BRT/BARNBECK
FRAME

VERMONT
FRAMES

SECOND FLOOR FRAMING PLAN
@ 15'-0" AFF ELEVATION

ROOF FRAMING PLAN

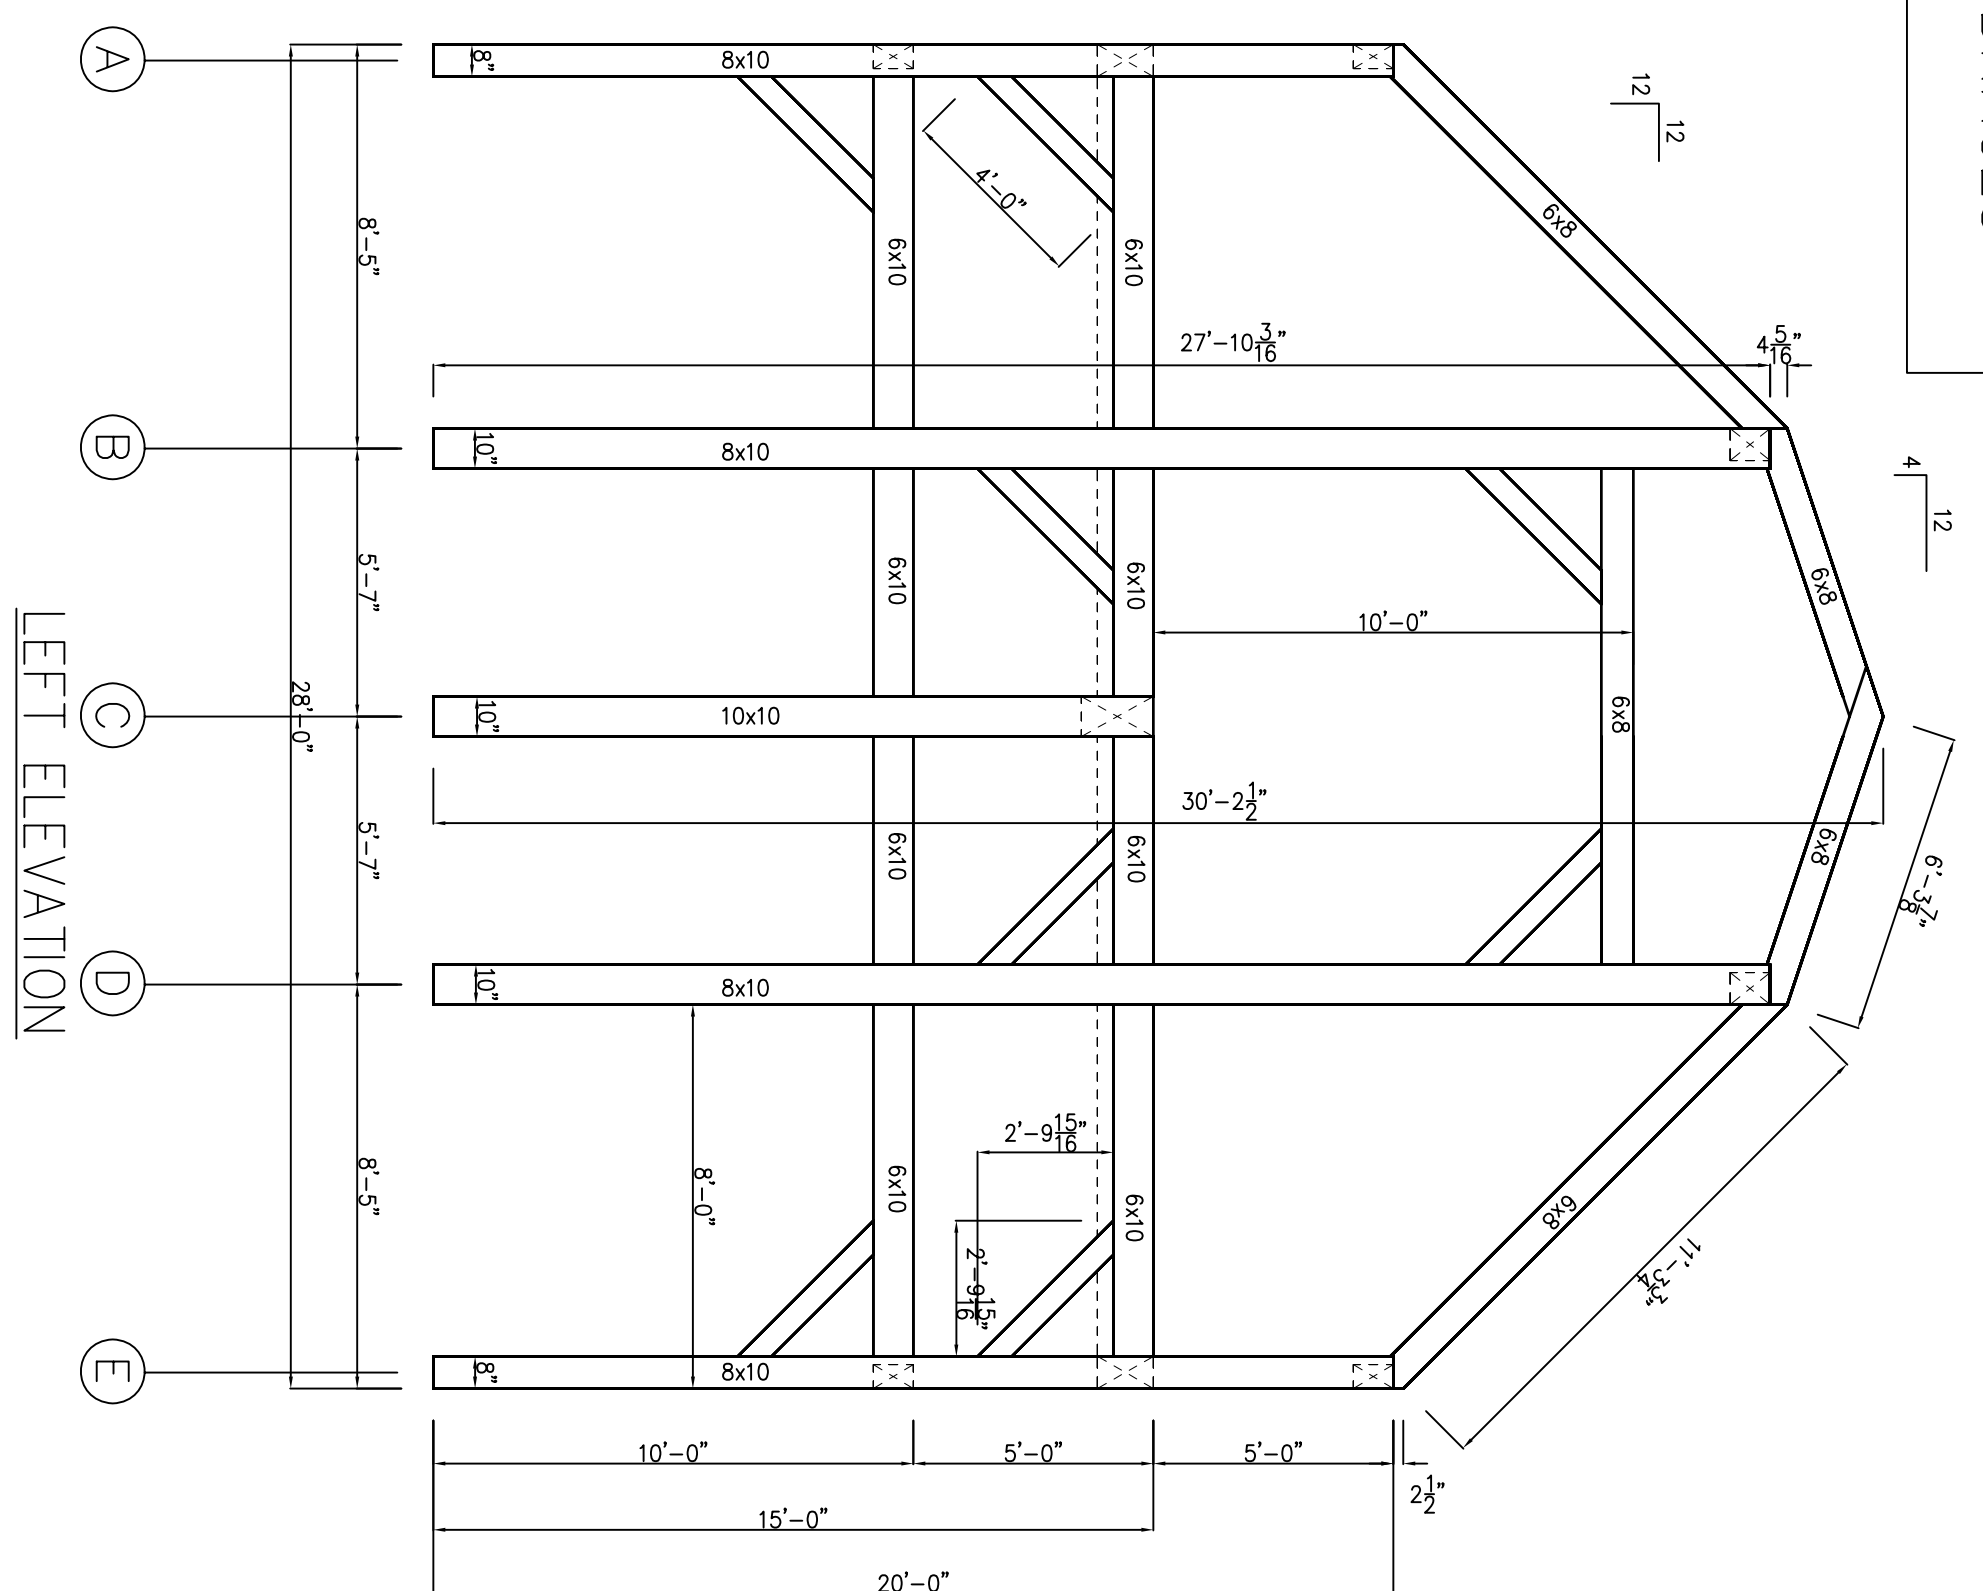
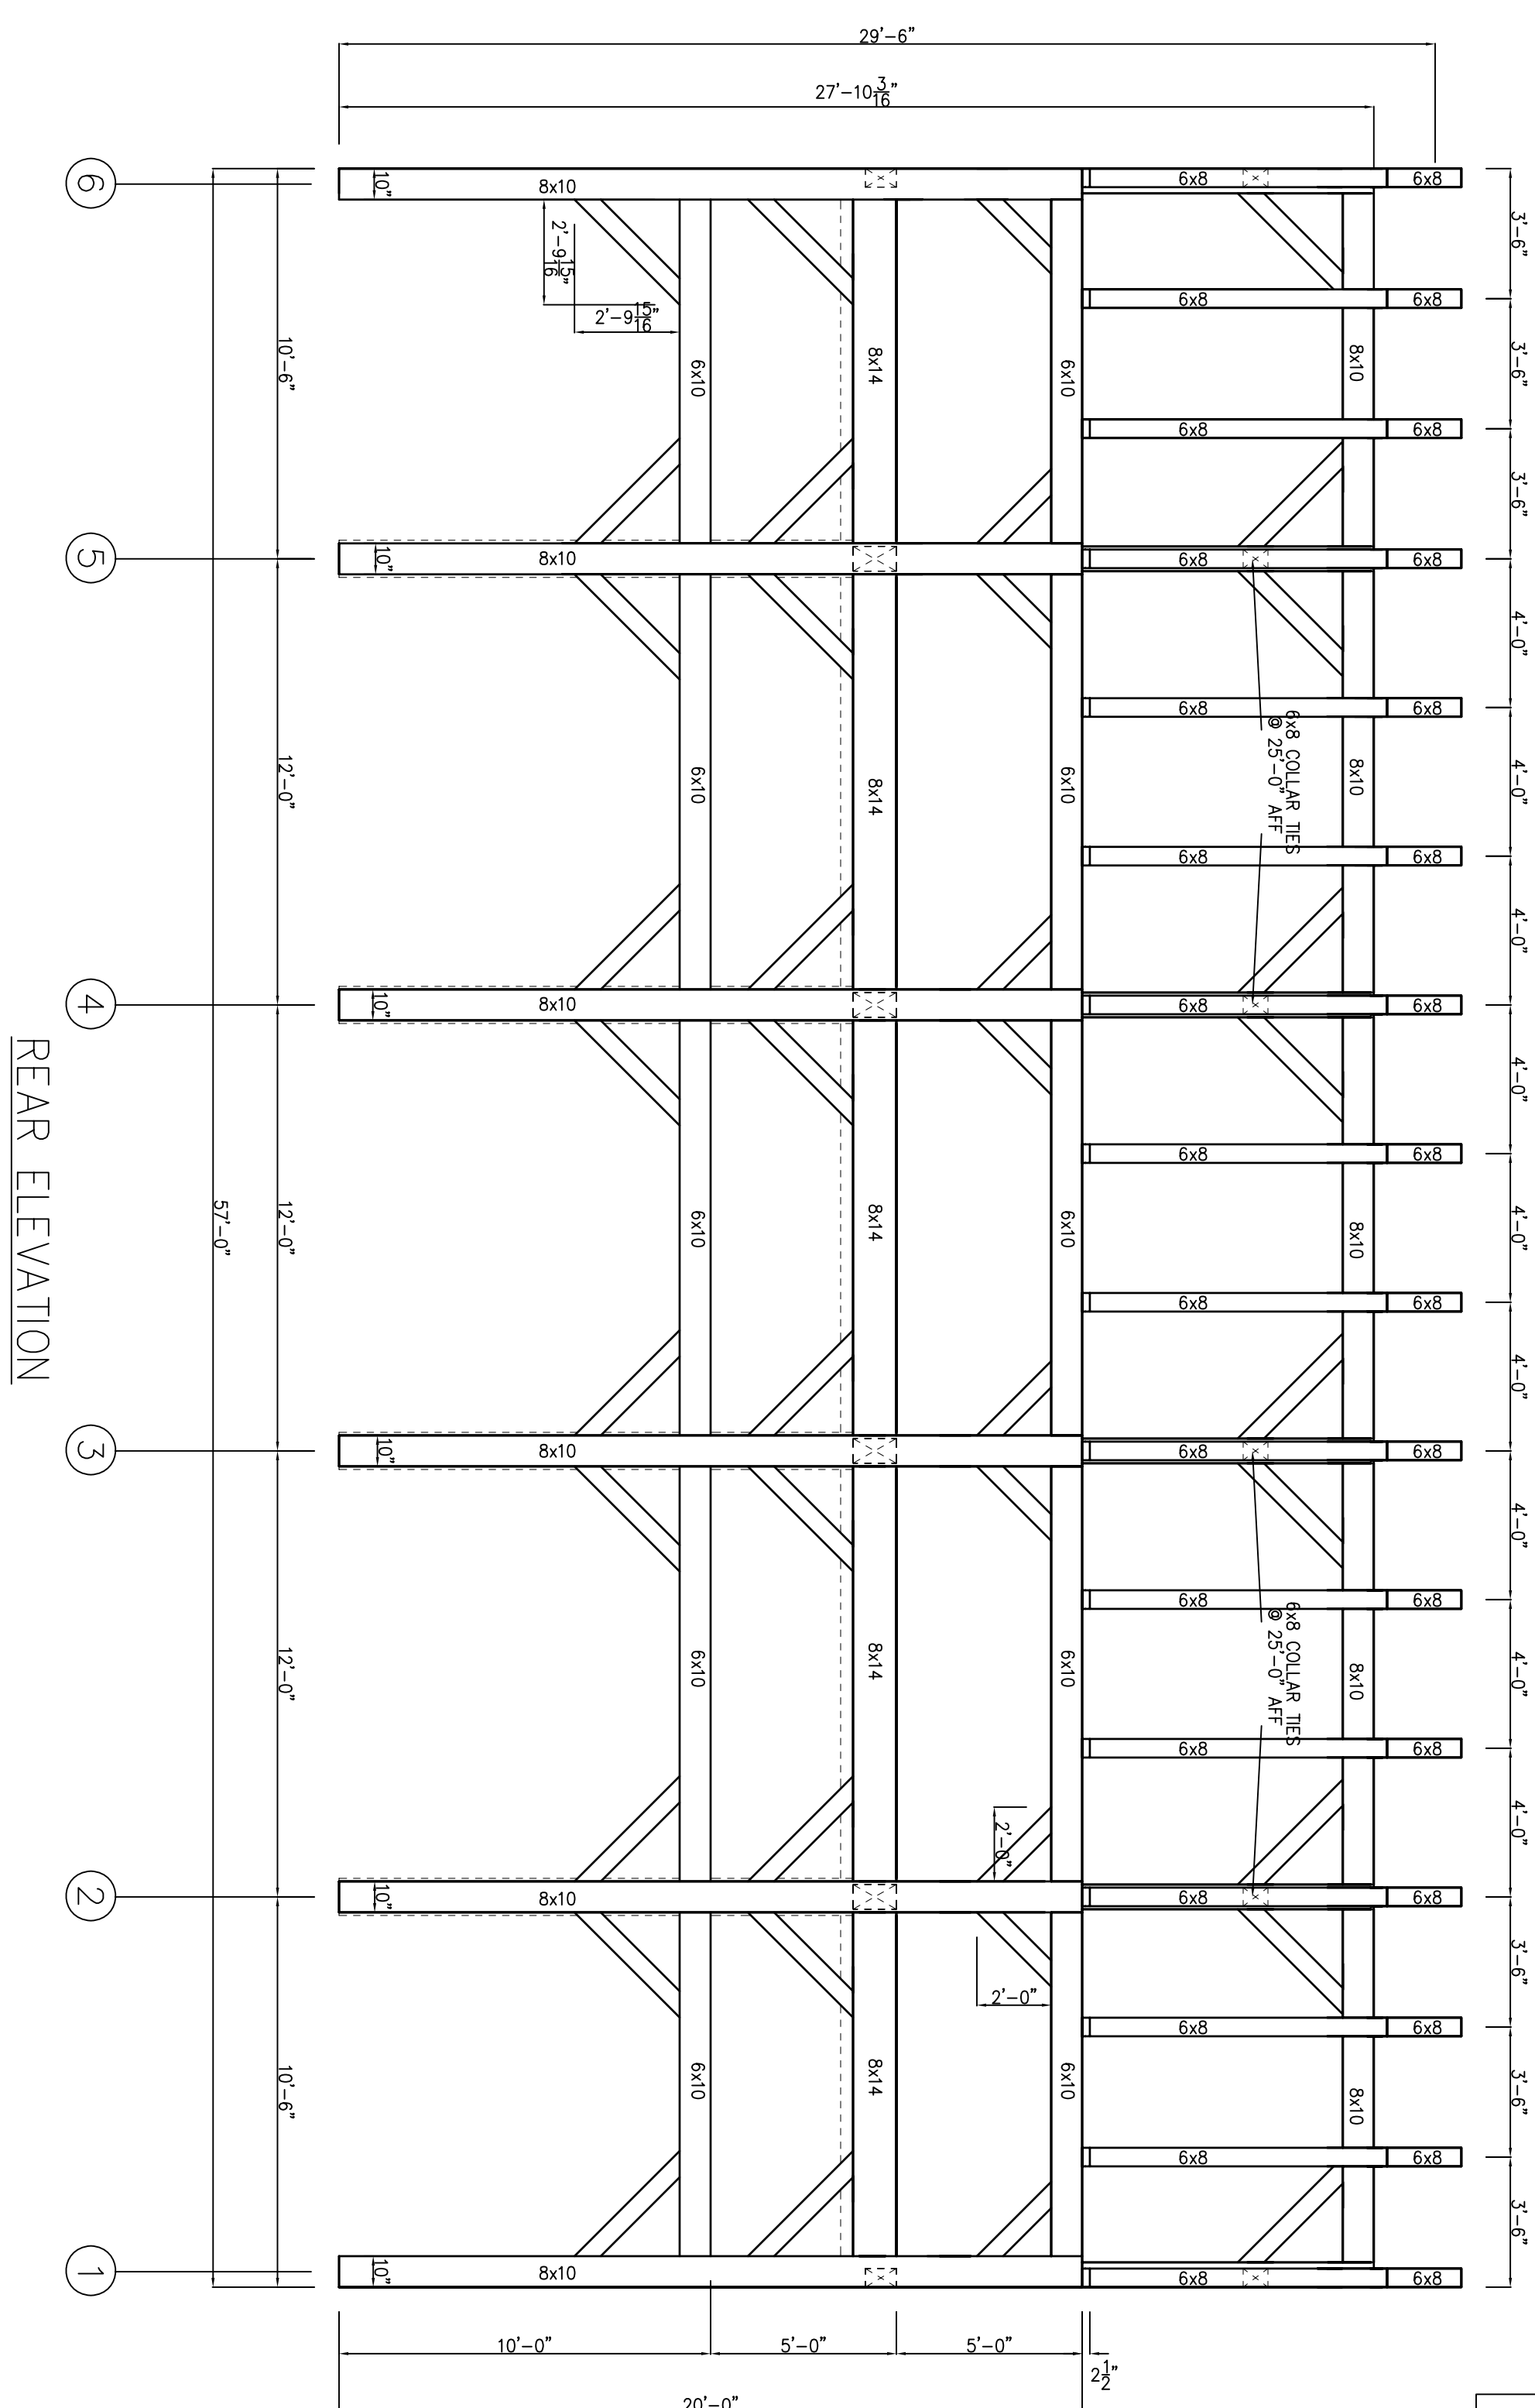
PLANS WILL NEED TO BE RE-SUBMITTED TO ENGINEER, DUE TO CHANGES IN INTERIOR POST LOCATIONS.
